TO: Sarah Thomas (Statutory Planning)  
 FROM: Blake Farmar-Bowers (Urban Design)  
 DATE: 26 March 2018  
 SUBJECT: Lot 9C & 10B River Boulevard, Richmond  
 APPLICATION NO: PLN16/1156 – Development plan application  
 [PLN17/1143 – Planning permit application]  
 DESCRIPTION: The development would allow for the construction of a 13 storey building (plus basement levels) containing dwellings shops, food and drinks premises (cafes), medical centre, childcare centre and restricted retail premises (noting a permit is not required for these uses).

SLR Consulting Pty Ltd (SLR) has been retained by the City of Yarra to provide a review of the acoustic assessment report for the mixed use development proposed for 10-20 River Boulevard Richmond.

Responsible Planner:	Sarah Thomas		
ESD Advisor:	Euan Williamson		
Date:	19.03.2018	Planning Application No:	PLN16/1156
Subject Site:	10-20 River Boulevard, Richmond		
Site Area:	Approx. 14,152m <sup>2</sup>	Site Coverage:	100%
Project Description:	13 storey mixed use development.		
Pre-application meeting(s):	None.

City of Yarra  
10 & 20 River Boulevard, Richmond - Peer Review  
Review of the Environmental Winds Test Report

**Furniture set-out**  
Suggested furniture set-out at street tree locations (Typical Plan & Section).

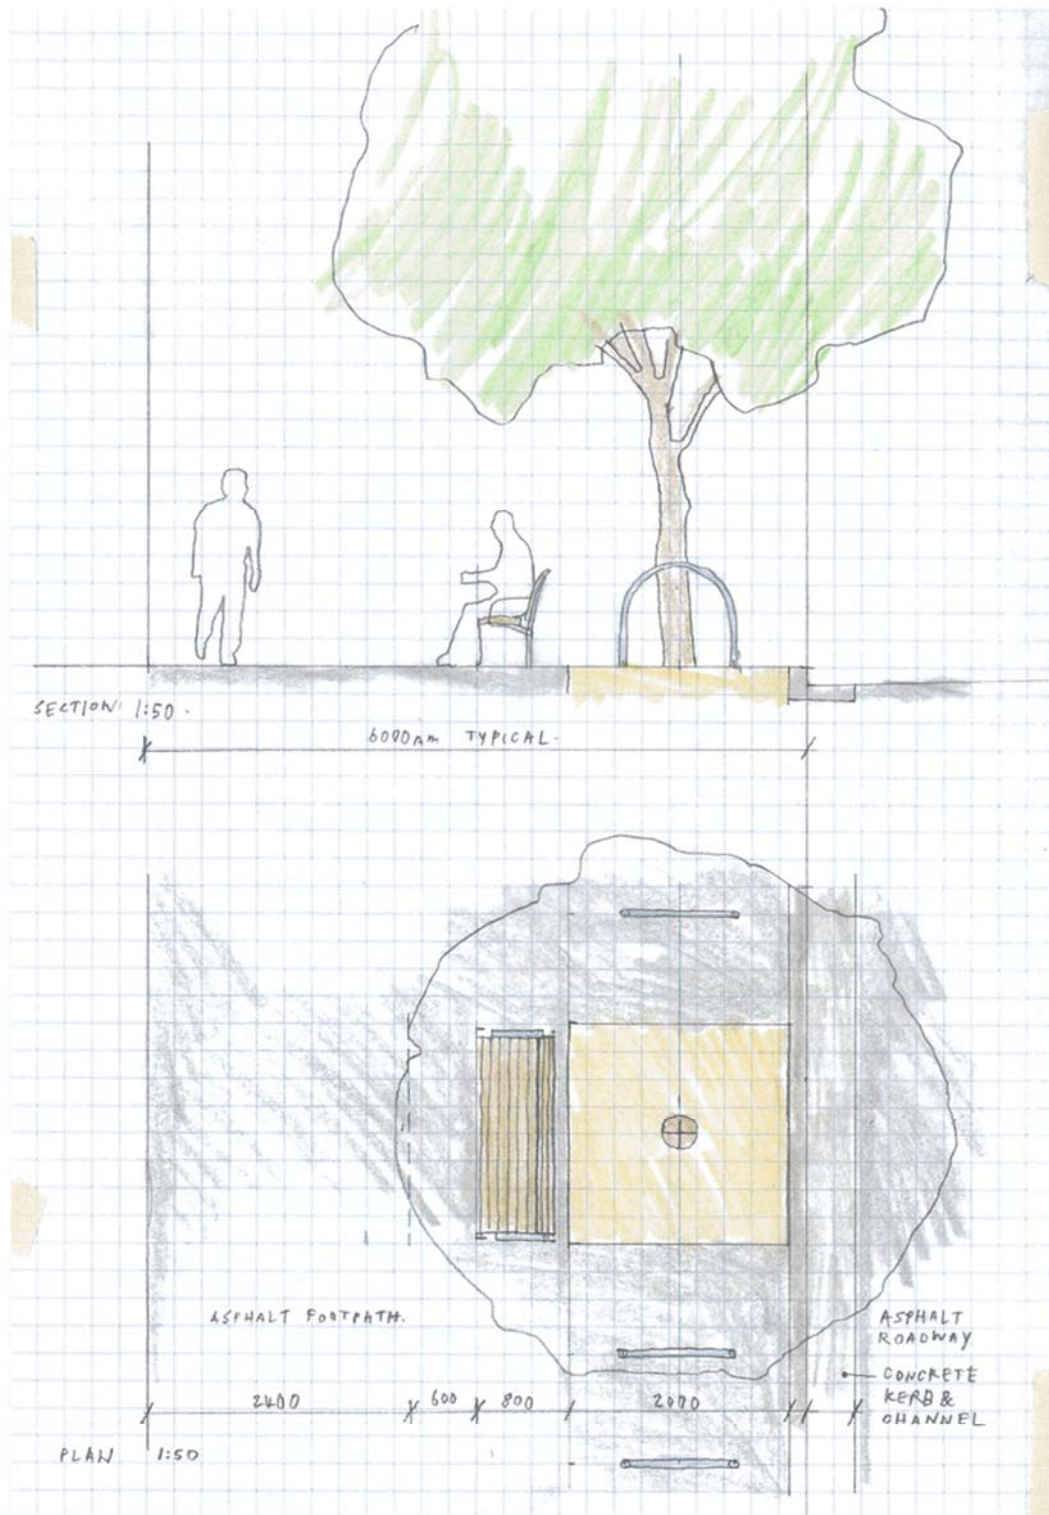
Proposed street furniture should be distributed more evenly to align with tree planting and breadth of commercial destinations. Furniture locations should be more responsive to building use and entries. Refer to example below for suggested furniture set-out at street tree locations (Typical Plan & Section).

Figure 1: Building entrances at ground floor.

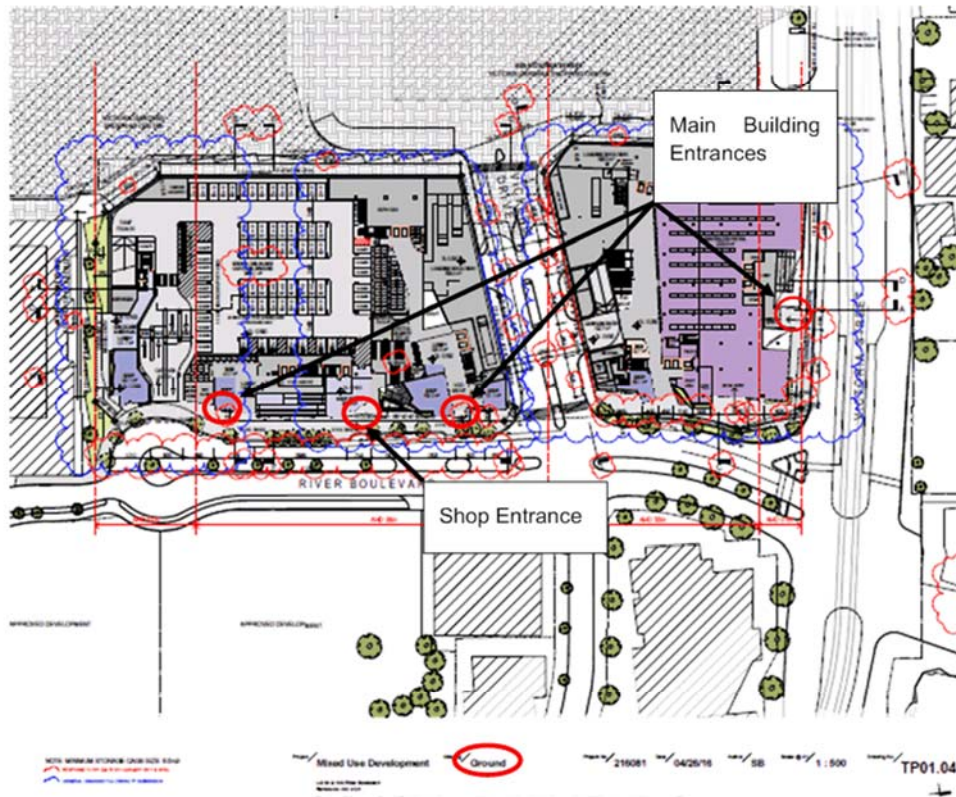
- The report used the upper ground level plan (with no entrances shown, see Figure 2 in the attachment) instead of the ground level plan. Upon review of the ground level plan, the main building entrances on River Blvd and Victoria Street, as well as shop entrance at River Blvd (see Figure 1 in the attachment), should be assessed against the standing criterion in Vipac's practice. Although the wind speeds at these locations were not measured in the report, from the closest measurement results (Locations 8, 9, and 10) Vipac can conclude that the entrances on River Blvd would fulfil standing criterion for all wind directions. For the entrance on Victoria Street, the closest measurement location is number 19, at which the measurement indicated all directions except the north fulfilled the standing criterion. The walking comfort criterion is fulfilled for the north direction. Due to the set-in entrance design, this entrance would be expected to have more quiet wind conditions than Location 19. As such, the front of this entrance would be deemed to fulfil standing criterion as well.

Figure 2: Measurement Locations in the report  
Note: this is upper ground level in the drawing set provided

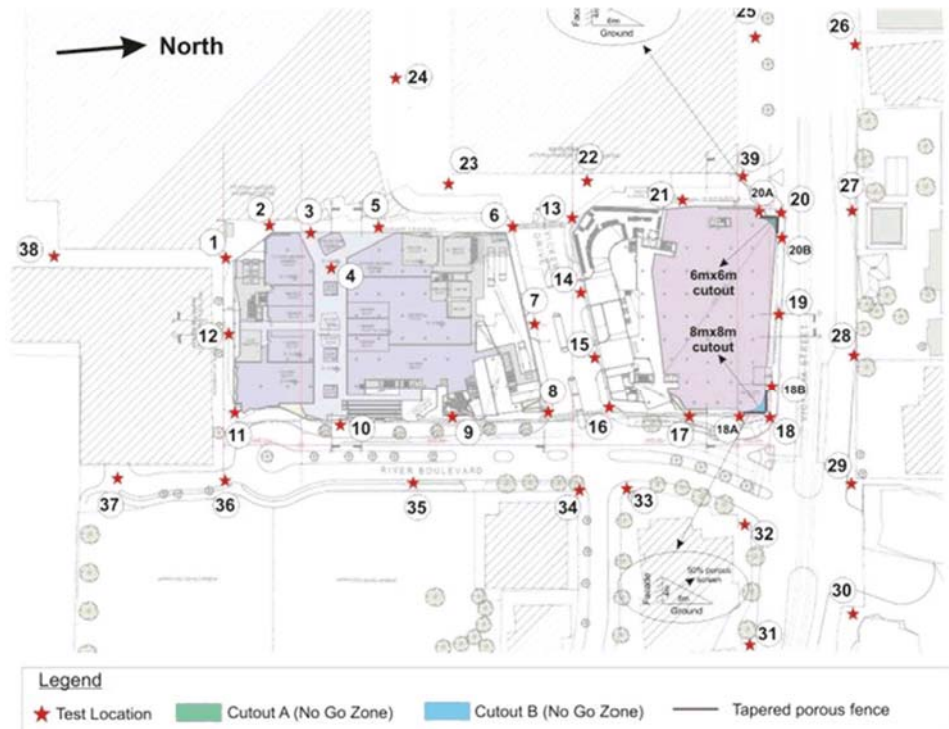
- The Conclusions indicated that all test locations fulfil the recommended wind criteria for the basic configuration with amelioration strategies. The amelioration strategies can be found in Figure 5a on Page 21.
